EXECUTIVE SUMMARY

Gorman-Rupp is pleased to announce our 2" Super T Series® pump models that come standard with an Eradicator® style self-cleaning wearplate*.

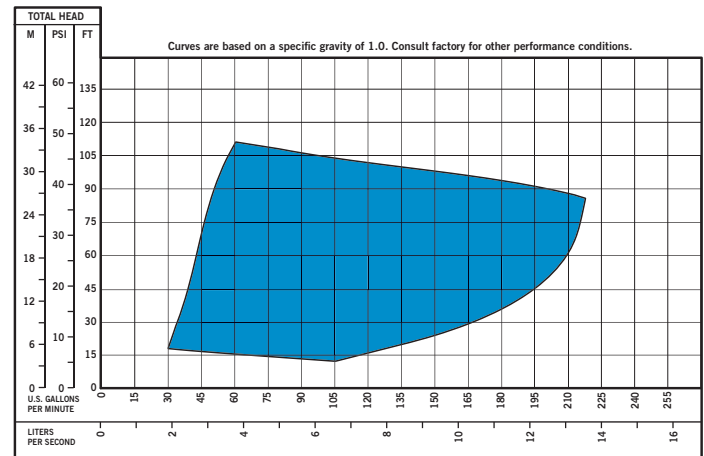
The rotating assembly is interchangeable with 2" T Series® Classic models and the overall pump footprint remains the same. Common parts between the 2" T Series Classic and the 2" Super T Series include: impeller, impeller shaft, seal assembly, outboard and inboard bearings, seal plate and wearplate. Non-interchangeable parts include: volute casing and back coverplate assemblies.

THE INSPECTION COVER
ALLOWS FOR EASY IMPELLER
ACCESS AND ROUTINE
MAINTENANCE. THE DESIGN
GREATLY REDUCES CLOGGING
AND MAXIMIZES UPTIME.
